Application of Future Capital Investment for a Major Modification to zoning conditions pursuant to CZ-20-1243972 to reduce the number of single-family detached lots from 19 to 6 lots in the RSM (Small Lot Residential Mix) zoning district, at 1347 Bermuda Road.

PETITION NO: N10-2022-2260 CZ-22-1246090

LOCATION: 1347 Bermuda Road, Stone Mountain, Georgia 30087

STAFF ANALYSIS

SITE PLAN

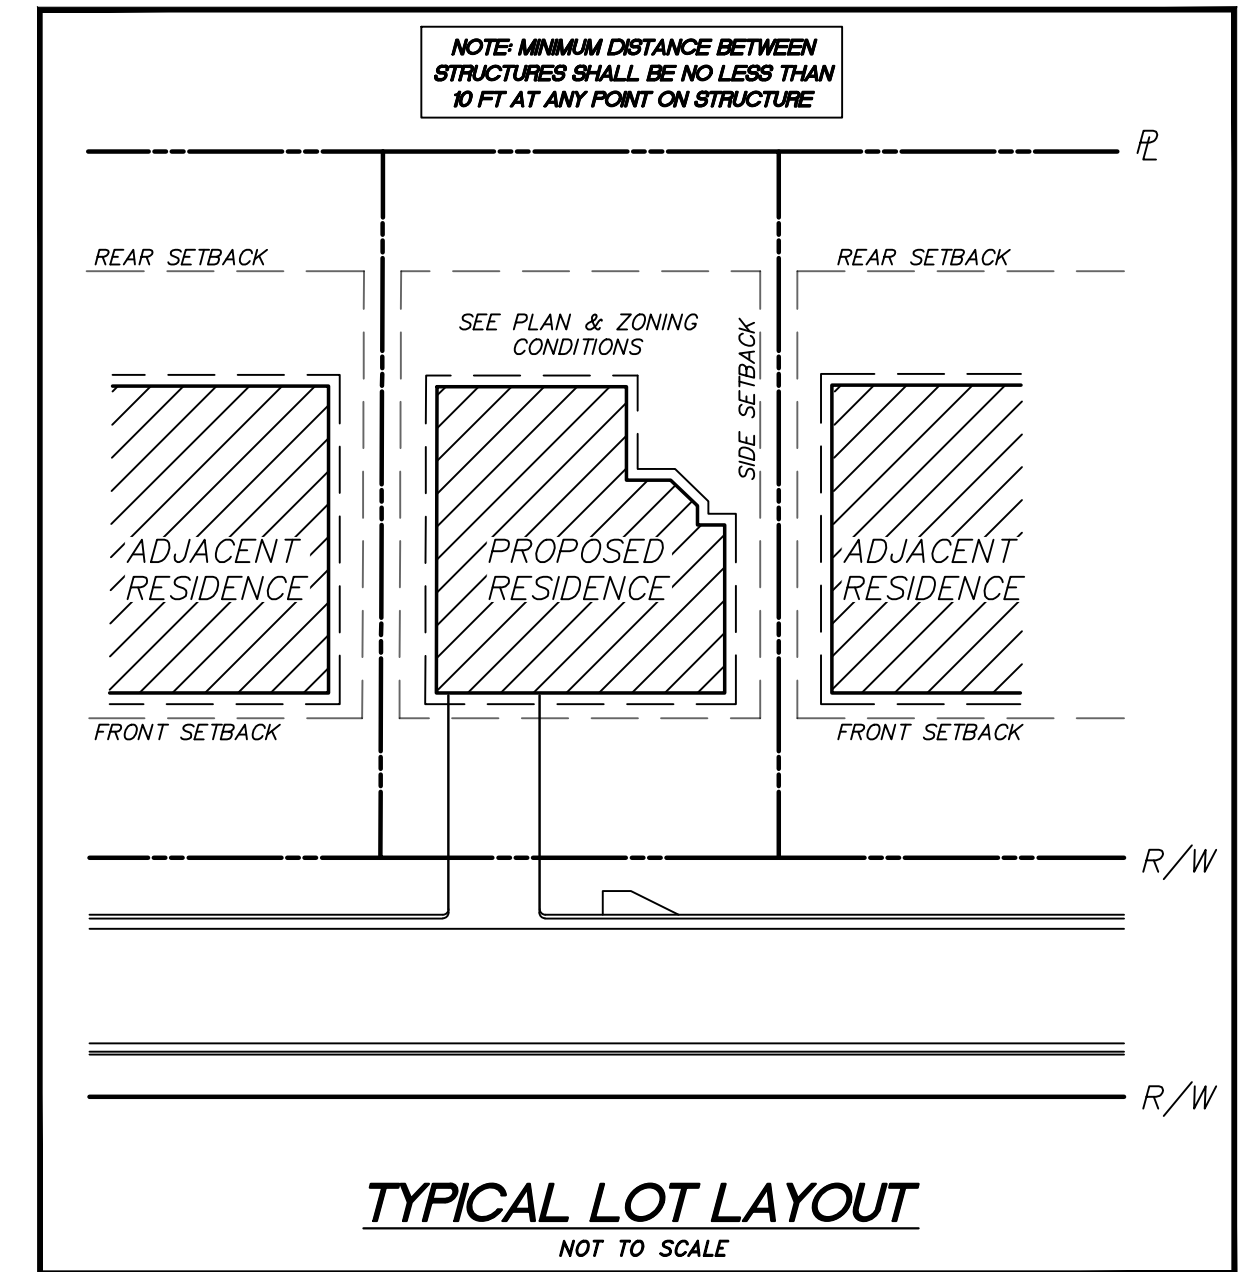
Notwithstanding these positive site plan features, the revised plan proposes a different access and building orientation scenario than what was originally approved. The previously approved plan provided access to all the homes via a new public street with all units facing the interior of the project site, while the proposed plan provides access via a shared access driveway with all units fronting along and facing Bermuda Road (see attached). The Planning Department would prefer that the shared access driveway be relocated behind the proposed homes so that the garages would not be visible to the motoring public along Bermuda Road. The applicant has indicated that while that design scenario would be ideal, the steep topography of the site would prevent that from being implemented. However, the applicant indicates that the project will comply with the Bermuda Road landscaping condition that was previously adopted with the original RSM zoning approval (see Condition #15) which should hide the proposed garages from view as much as possible. The Zoning Board of Appeals (ZBA) will be required to review the proposed shared driveway on its merits since Sec. 5.7.5.F.2 of the Zoning Ordinance allows a maximum of two lots to share the same driveway and the plan shows shared driveway access to six lots.

More information is needed to verify compliance with stormwater management regulations. The Land Development Division indicates that the conceptual plan doesn't indicate the location of the stormwater management facility. The Land Development Division strongly recommends that a design professional investigate the site and identify location where runoff Run-off Reduction Volume (RRV) can be provided and re-design/revise the layout to comply with the RRV requirement (see attached interdepartmental comments from Land Development Division).

Conceptual plan doesn't indicate the location of the stormwater management facility. Location of stormwater management shall be shown or compliance with the County stormwater management regulations shall be explained.

Additional consideration must be given to the 10% downstream analysis. Runoff Reduction Volume shall be provided unless technical justification is provided regarding the unfeasibility. Strongly recommend investigating the site and identify location where RRV can be provided and re-design/revise the layout to comply with the RRV requirement.

Possible Variances: Proposed shared drive will be reviewed to verify compliance with Transportation Department and Zoning Ordinance requirements. From a conceptual standpoint Planning Department would prefer the access drive to provide access to the rear of the proposed lots. Show compliance with RSM requirements including but not limited to minimum lot area and lot width, required parking, parking lot landscaping, minimum open space, maximum building height, transitional buffers, streetscape improvements (sidewalks/street trees/street lighting), building materials, outdoor lighting, etc. The applicant is encouraged to discuss possible transportation improvements that may be required (if the rezoning is approved by the Board of Commissioners) with the county Transportation Department. The applicant is encouraged to contact Land Development Division of Public Works regarding required storm water management, floodplain, and stream

Therefore, it is the recommendation of the Planning & Sustainability Department that the request be "*Deferred Full Cycle*" to allow the applicant time to address the stormwater management regulations and re-design or revise the plan as needed to comply. Should the Board decide to approve the request, Planning Staff recommends the following conditions (additions from the previously approved zoning conditions are in **blue bold**, and proposed deletions are in ~~red strikethrough~~).
